PCN-20231006 TE0630-02 to TE0630-03 Hardware Revision Change

Company	Trenz Electronic GmbH
PCN Number	PCN-20231006
Title	TE0630-02 to TE0630-03 Hardware Revision Change
Subject	Hardware Revision Change
Issue Date	2023-11-06

This change affects all Trenz Electronic TE0630 SoMs: TE0630-02*.

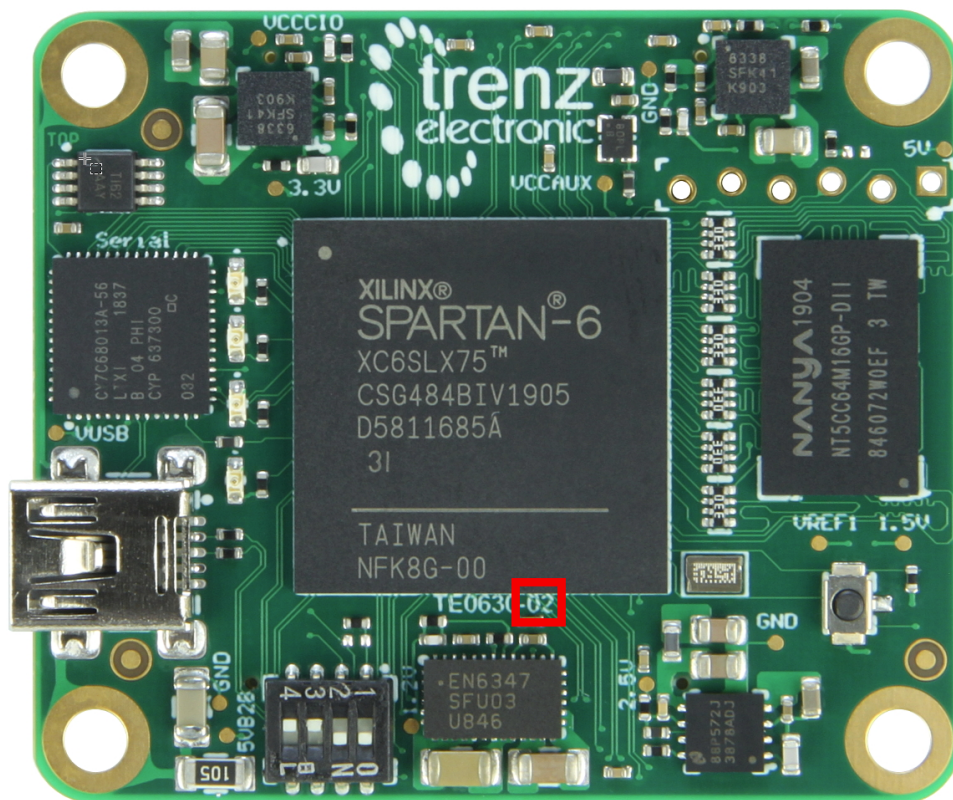
The revision number is shown on the top side of the PCB. Revision number position changes between REV02 and REV03 on top side of the PCB.
